Herschel/Planck

INSTRUMENT INTERFACE DOCUMENT

INSTRUMENT "SPIRE"

DOCUMENT CHANGE RECORD

**Figure 5.3-1: The Herschel Focal Plane, top view towards -X**

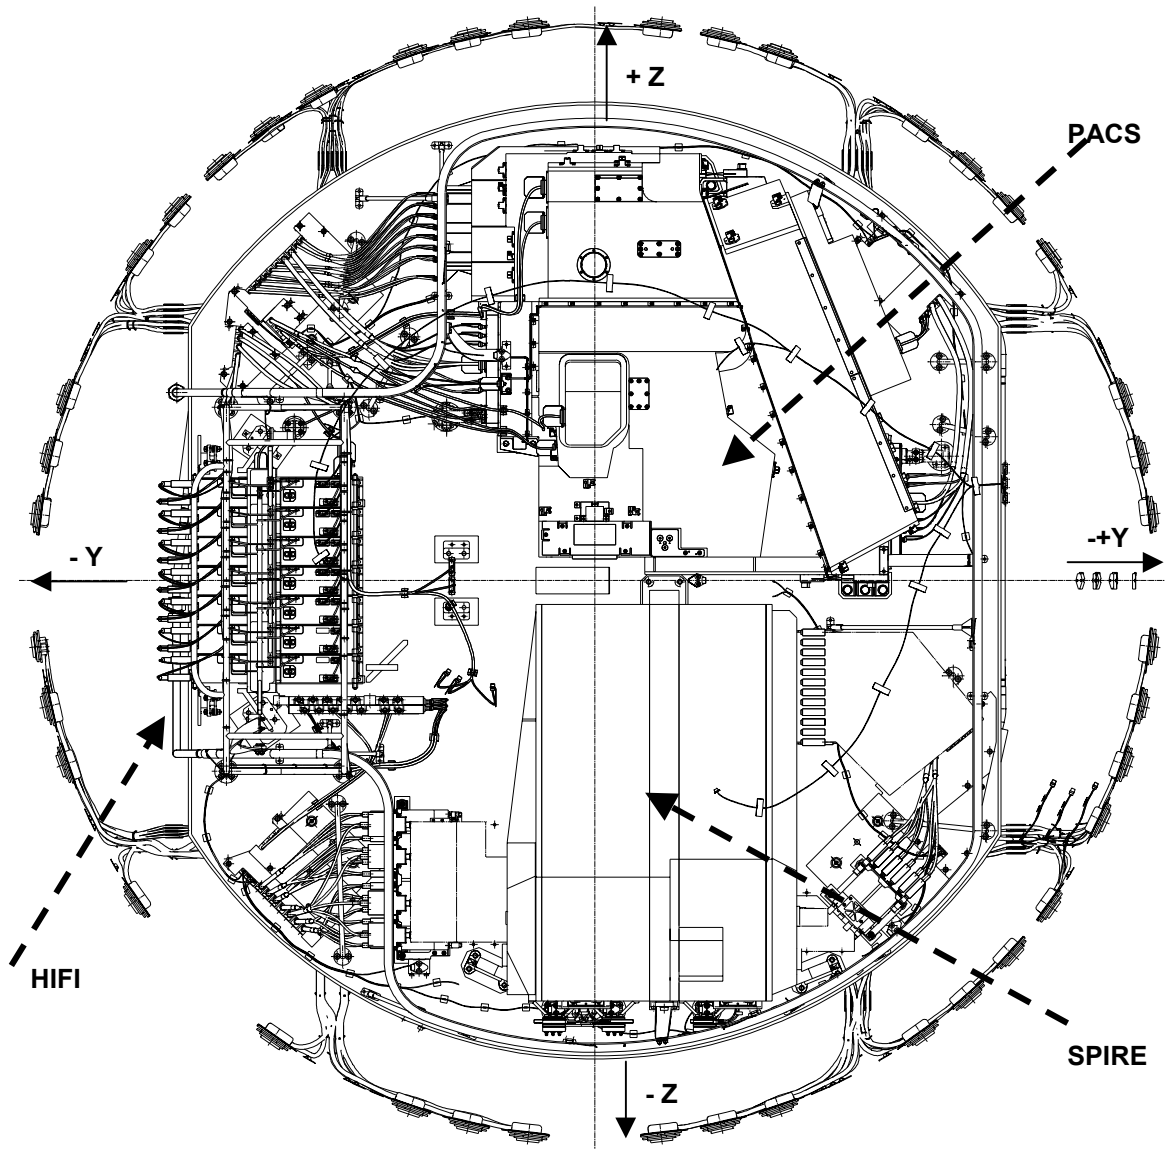
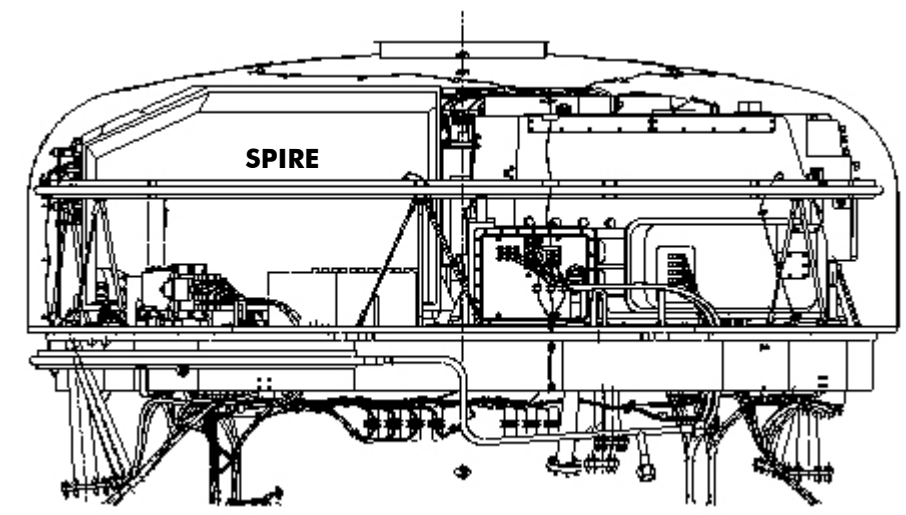
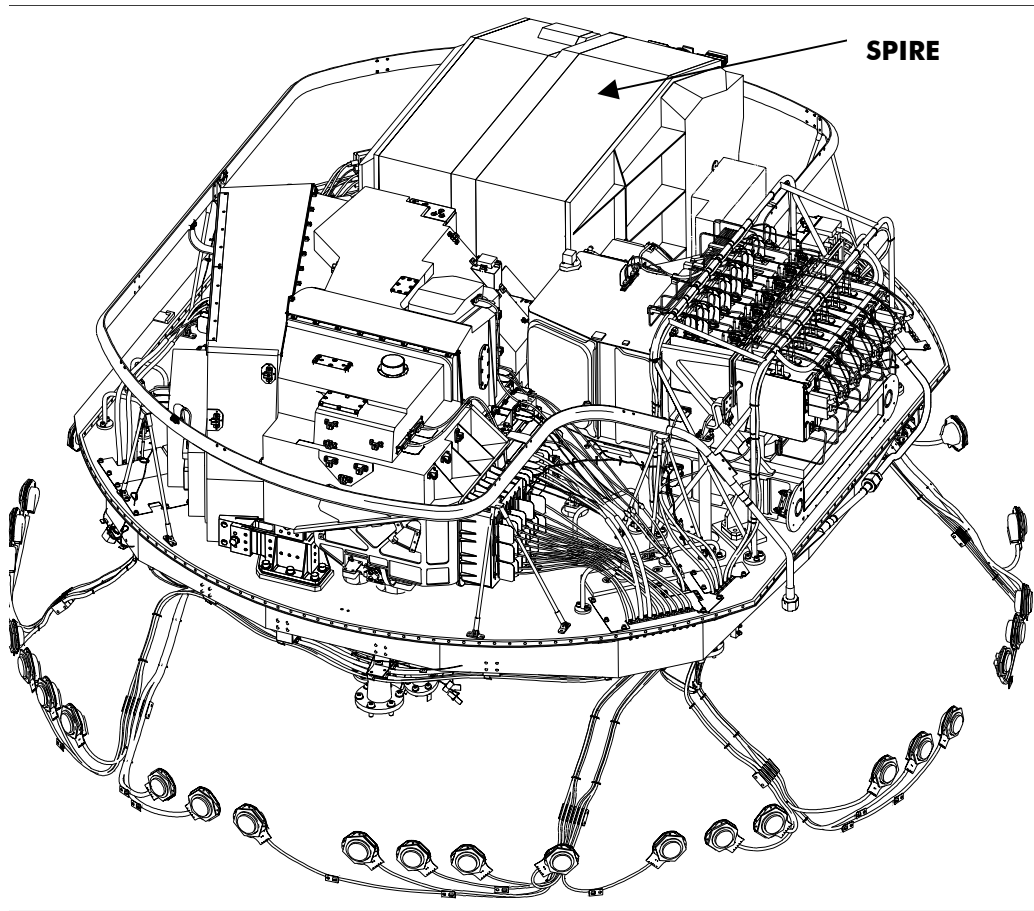
- New drawings from ASED (Horst Faas) figures 5.3-1 & 5.3-2 : applied

Figure 5.4-3 : SPIRE Spectrometer JFET rack external configuration

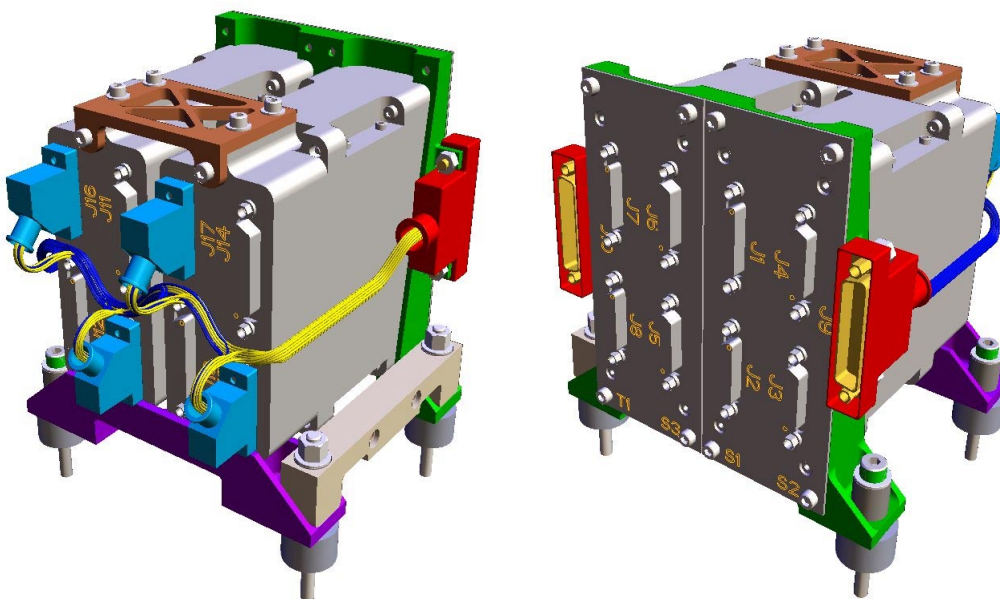
- HR-SP-RAL-ECR-049 : JFET 3D views (fig 5.4-3 & 5.4-4)

Figure 5.4-6 Isometric view of the DPU

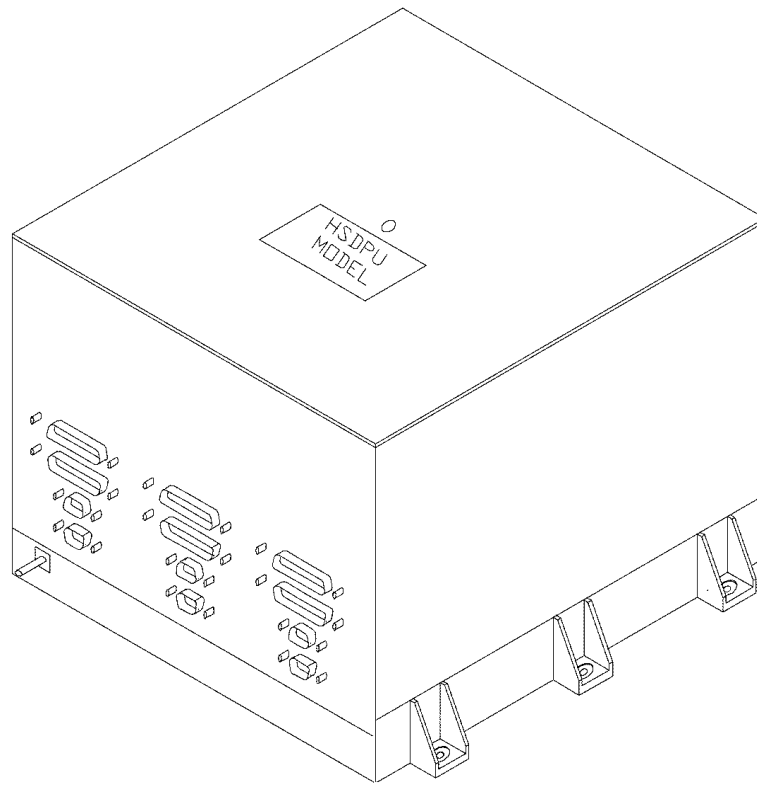
- Comments from John Delderfield (mail 05/06/03) new figure 5.4-6: applied

Figure 5.8-1 Spire optical beam envelope as it leaves the HSFPU

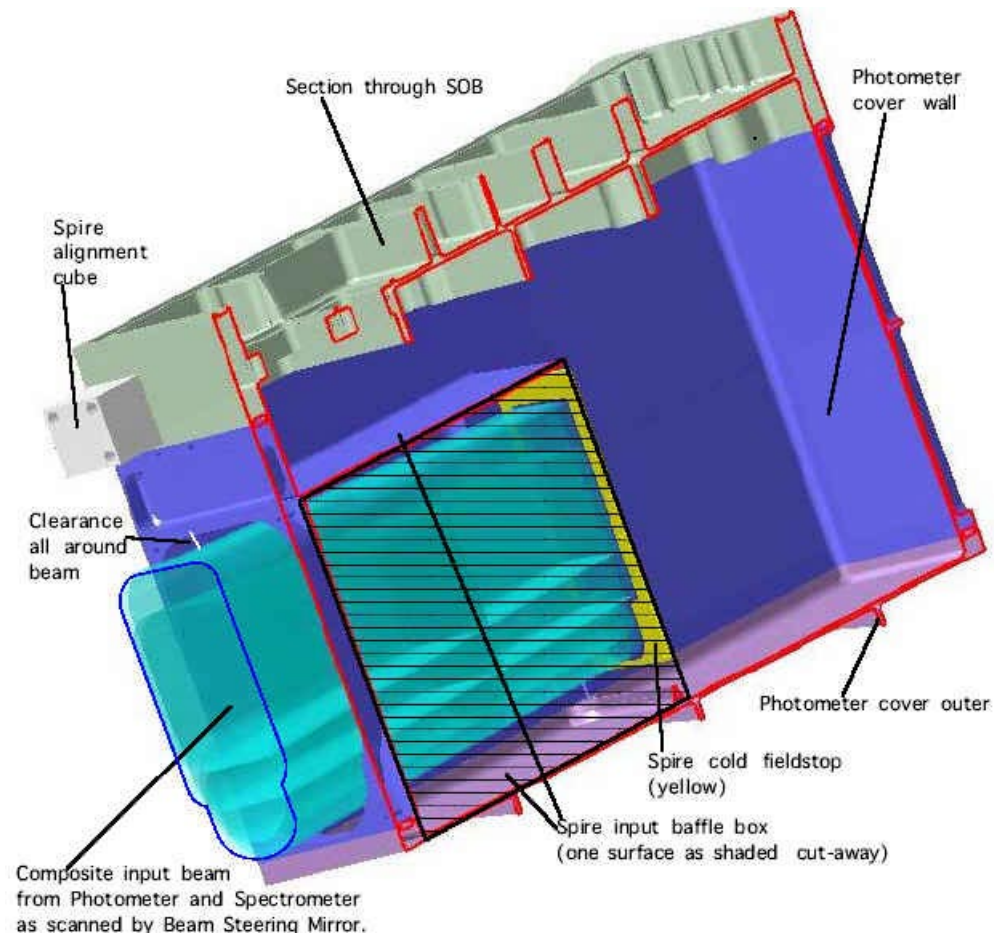
- HR-SP-RAL-ECR-050: SPIRE optical beam illustration fig 5.8-1

The figure 5.8-1 here under takes into account the removing of SPIRE shutter
